**Santos**

18 April 2019

I refer to the assessment application for petroleum activities for the Cherokee and Piute Project (RPI19-001 – Cherokee and Piute) and your request for further information dated 9 April 2019. A response to the matters raised in the requirement notice are addressed in this document and attachments as outlined in Table 1 (see over page).

**Table 1: Response to Requirement Notice Dated 9 April 2019**

**ATTACHMENT 1 – OVERALL EXTENT OF PROPOSED ACTIVITIES**

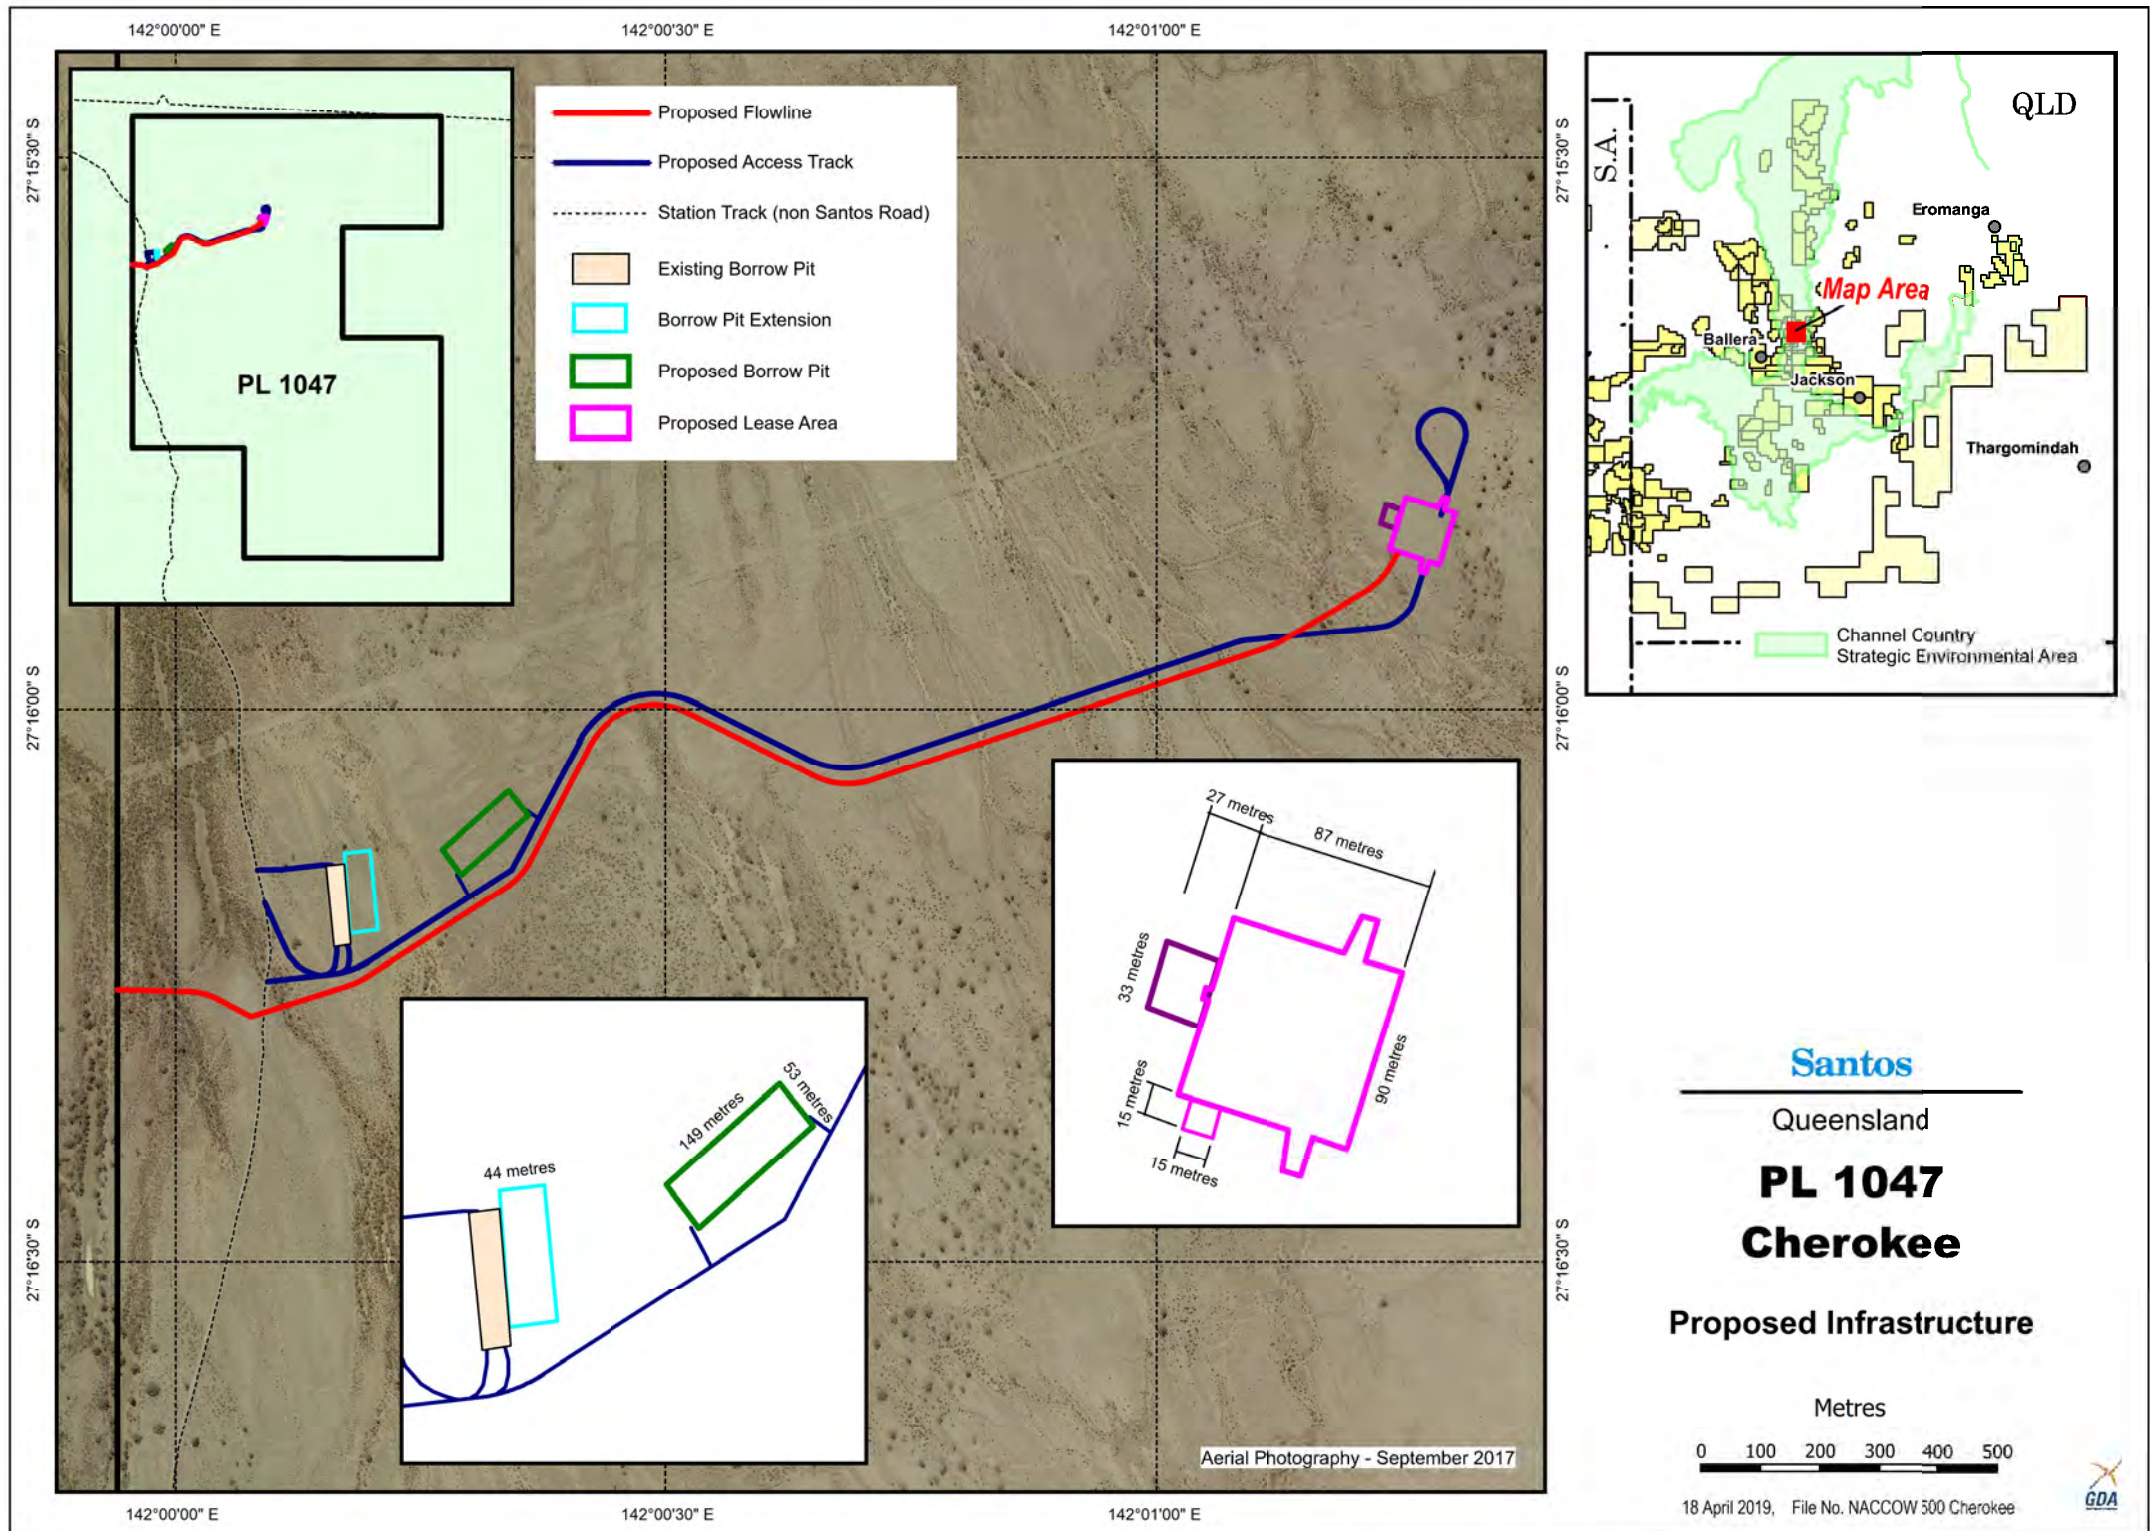
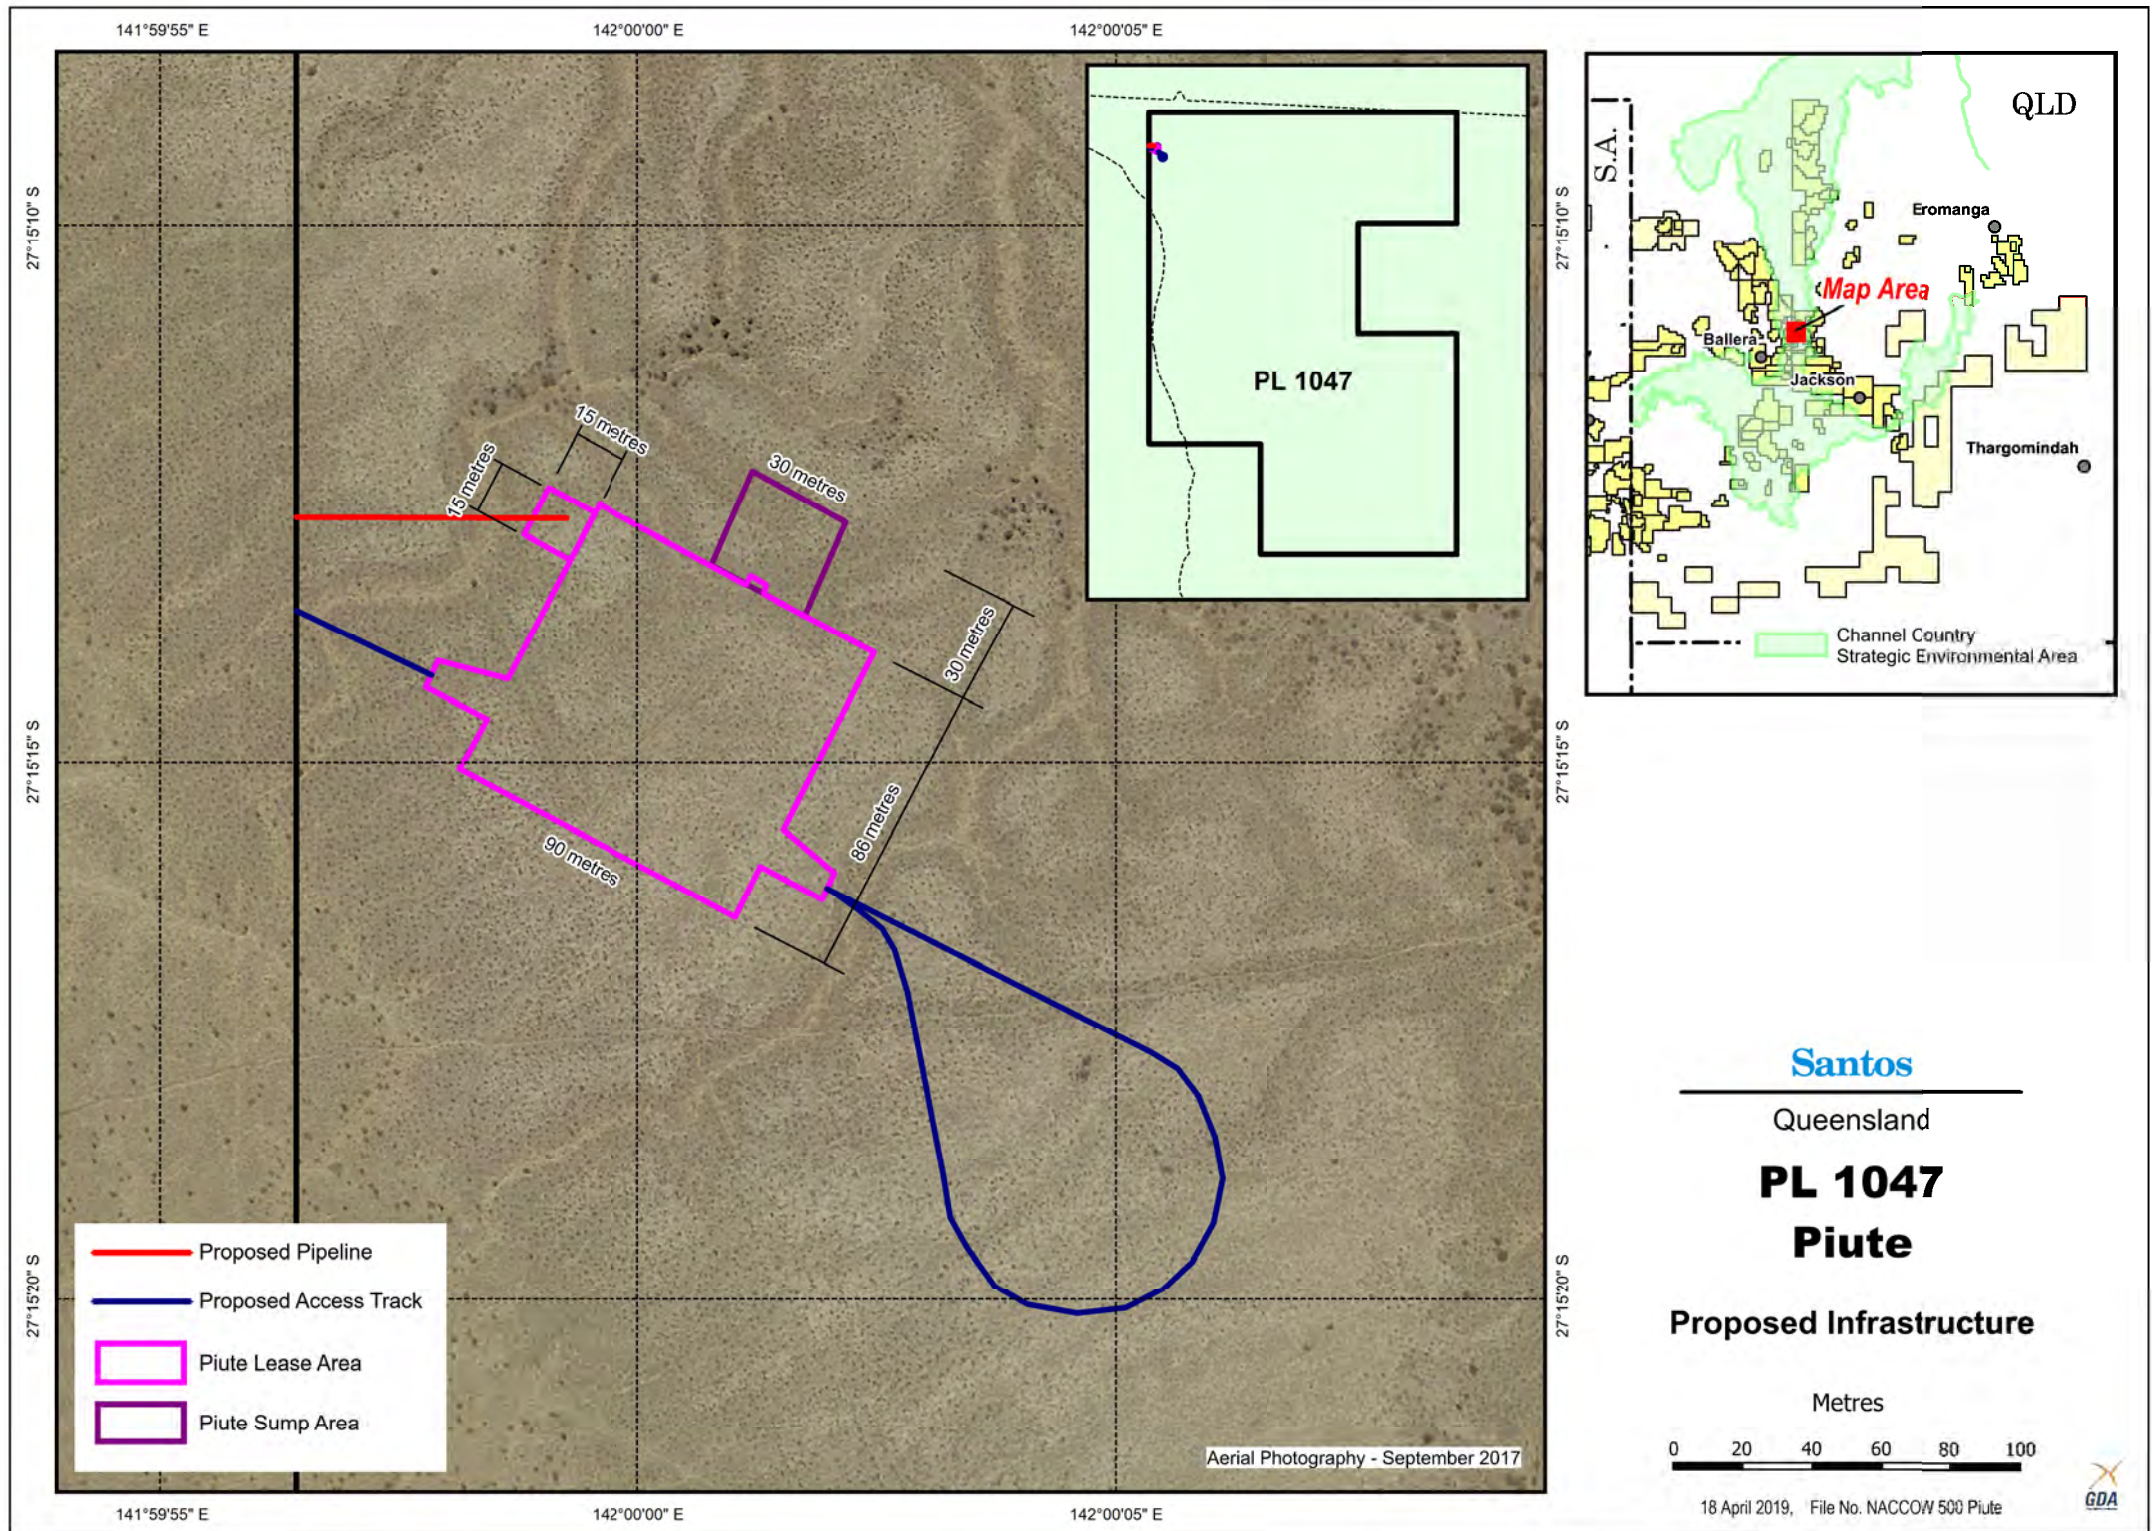
Request	Santos Response
<p><b>Item 1</b></p> <p>The proposal plans contained within the supporting application material do not sufficiently identify the extent of the proposed activities. Please provide dimensions of the overall footprints for each of the proposed wells and the borrow pits on legible proposal plans. Overall X and Y axis is sufficient for each.</p> <p>In addition, provide the footprint of the Channel Country SEA – designated precinct on the plan or plans.</p>	<p>Table 1 within Section 2.0 of the Assessment Report (lodged in support of the application) details the total maximum proposed surface disturbance. This was provided given that the final locations of infrastructure may change slightly post ground-truthing (as discussed within the Assessment Report). The environmental attributes and potential impacts to environmental attributes detailed in the Assessment Report has been established based on the total maximum proposed surface disturbance.</p> <p>The anticipated extent of the proposed activities is provided in Attachment 1. This outlines the anticipated footprint, including dimensions, for each of the proposed wells (Cherokee 1 and Piute 1) and borrow pits (Cherokee 1 Borrow Pit – New, Cherokee 1 Borrow Pit – Extension). Attachment 1 also shows the anticipated footprint of the proposed project in relation to the Channel Country SEA footprint (shown in both of the insets).</p>

**ATTACHMENT 2 – EXISTING SEISMIC LINE ROUTES AND PROPOSED CHEROKEE 1 ACCESS TRACK AND PIPELINE**

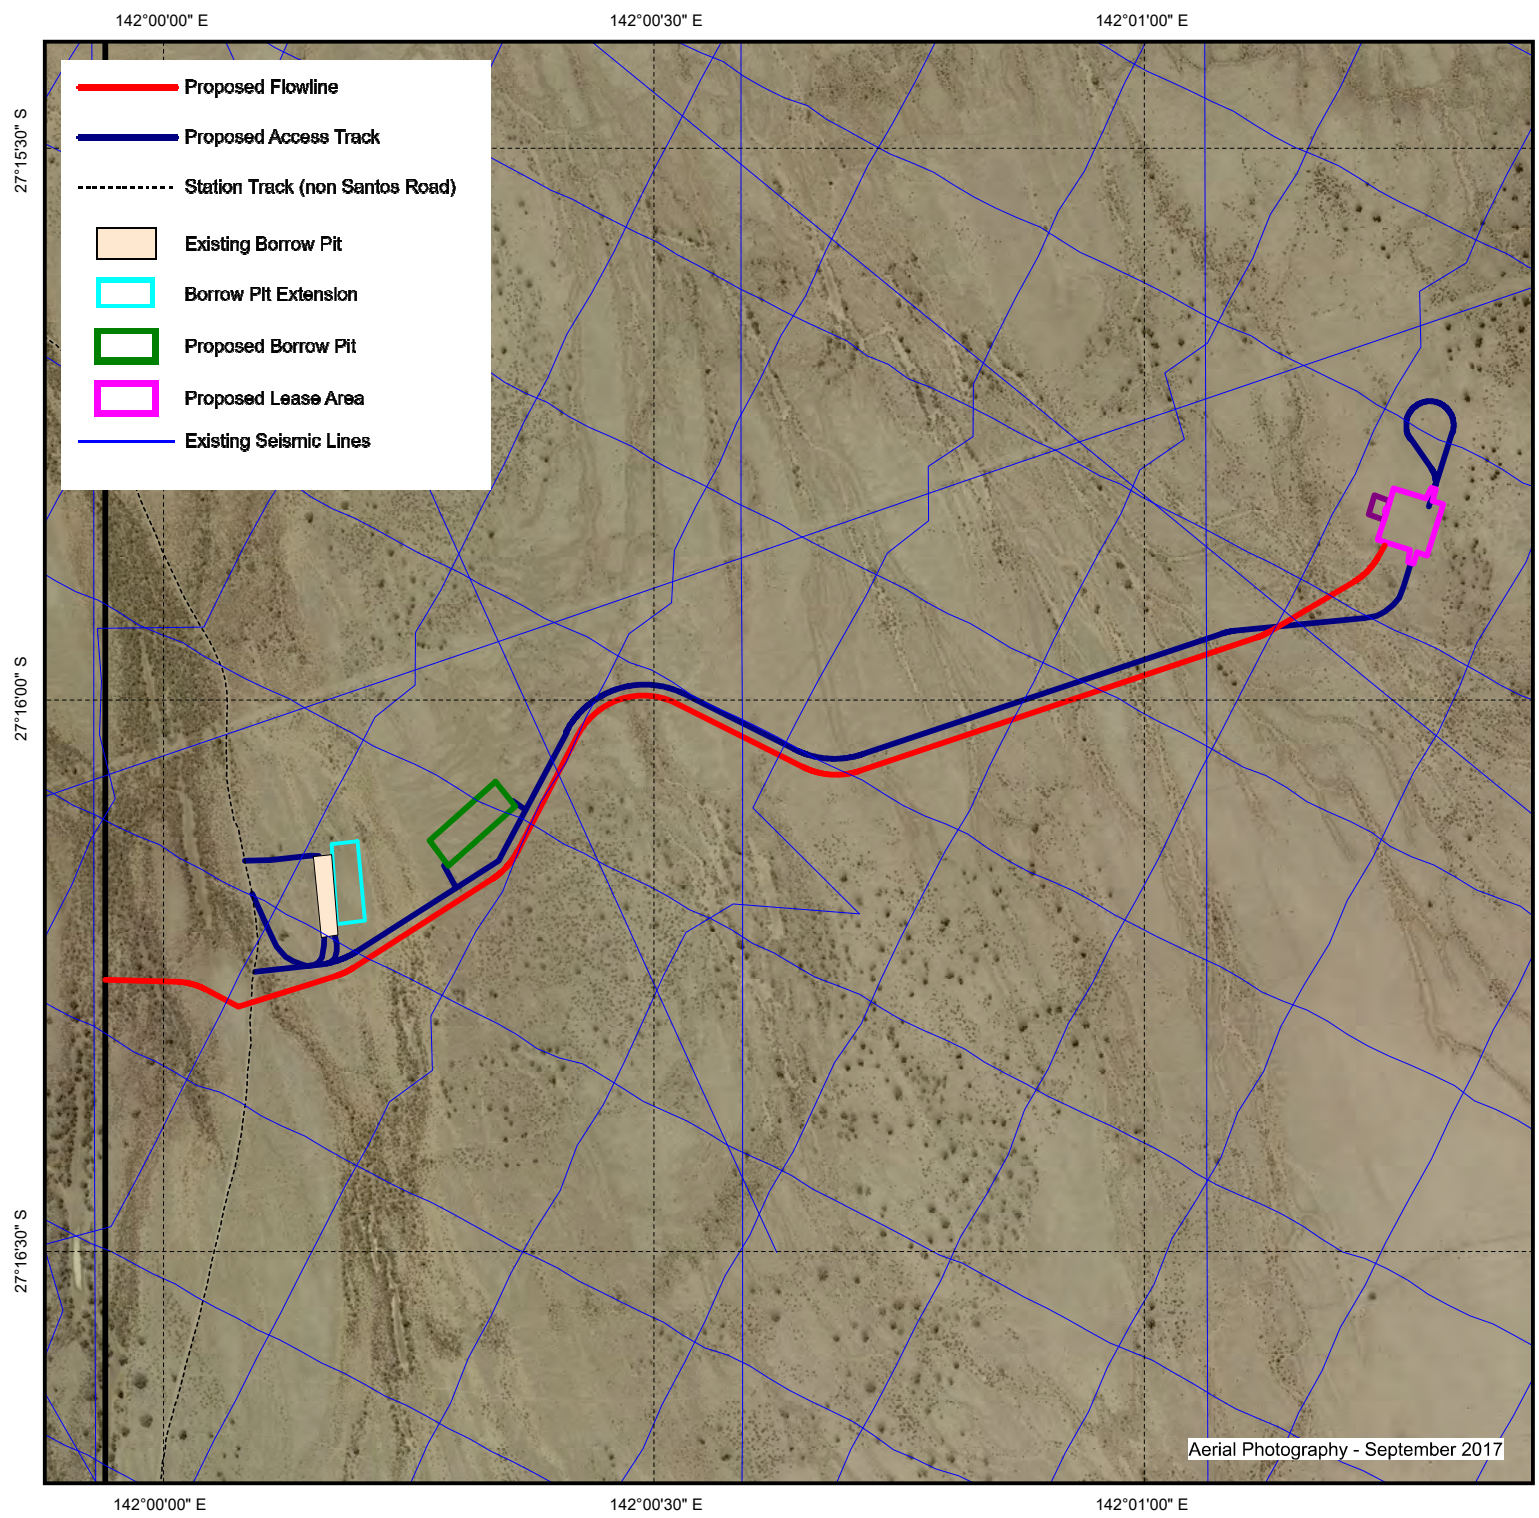
<p><b>Item 2</b></p> <p>Section 2.3 of the Assessment Report (lodged in support of the application) addressed access tracks, noting one 'of these access tracks follows a pre-existing seismic line route'. Please identify the access track referred to and explain how the other access track route was arrived at. (Note: applicants typically provide a plan to identify the route options that were explored).</p>	<p>A section of the Cherokee 1 access track follows 3D seismic line 00-CS5336. A section of the Cherokee 1 pipeline also follows a pre-existing seismic line, 00-CR1576. These seismic lines were part of the 2000 Central Fields 3D Survey Program. Attachment 2 shows the sections of the Cherokee 1 access track and pipeline that follow existing seismic line routes.</p> <p>The location of all infrastructure for the Cherokee 1 and Piute 1 project was planned on desktop and continually refined to ensure minimal overall potential environment impact. The drilling locations (Cherokee 1 and Piute 1) were limited based on downhole requirements and needed to remain within a restricted zone in order to maintain economic feasibility. Refinements of the drilling locations were made to move the wells back further from waterways and to orientate the drilling lease to minimise the amount of clearing required / avoid removing mature trees as much as possible.</p> <p>The access track routes (Cherokee 1 access track and Piute 1 access track) underwent a similar planning and refinement process, in conjunction with the drilling locations. Refinements to the access track routes focused on minimising potential environmental impacts and disturbance to visible vegetation and drainage lines.</p> <p>Attachment 3 shows the proposed access track route alternatives that have been considered and the refinement of these routes. Below is a summary of the planning and refinement that took place.</p> <p><b>Cherokee 1 access track</b> – the initial route [Aqua] was originally selected as it provided the most direct access from the existing Station Track to the drilling location. The first route refinement [Yellow] co-located the Cherokee 1 access track route with the Cherokee 1 pipeline route as much as practicable, minimising the amount of disturbance. The second route refinement [Orange]</p>

Request	Santos Response
	<p>also co-located the linear infrastructure and will avoid more dense vegetation in comparison to the previous proposed routes as it follows a section of pre-existing seismic line. The final alignment selected [Blue] is similar to the second route refinement, though it has been optimised slightly to avoid more dense vegetation resulting in less environmental disturbance. The final alignment may be modified further during the pre-clearing should it be determined that areas (once ground-truthed) require additional management. Note: existing disturbance north and running parallel to the Cherokee 1 linear infrastructure is the Carpentaria Gas Pipeline (PPL 41) and not an existing access track that could have been utilised (as it appears in Attachment 3).</p> <p><b>Piute 1 access track</b> – the initial route [Aqua] was originally selected as it provided the most direct access from the existing Station Track to the drilling location (note existing Station Track is located on an adjacent tenure to PL 1047). The first route refinement [Yellow] co-located the Piute access track route with the Piute 1 pipeline route where possible, and allowed for loop road to be slightly set back from the nearby Cooper Creek. The final alignment selected [Blue] is similar to the first route refinement, though it allows for both the drilling pad and loop road to be adequately set back from the nearby Cooper Creek resulting in less potential for environmental disturbance. All route options considered for the Piute 1 access track avoid areas of dense vegetation as far as practicable. Existing disturbance was also considered, however there are no existing roads, and it wasn't feasible to utilise pre-existing seismic lines for this site (would have required more surface disturbance than the alignment selected).</p>
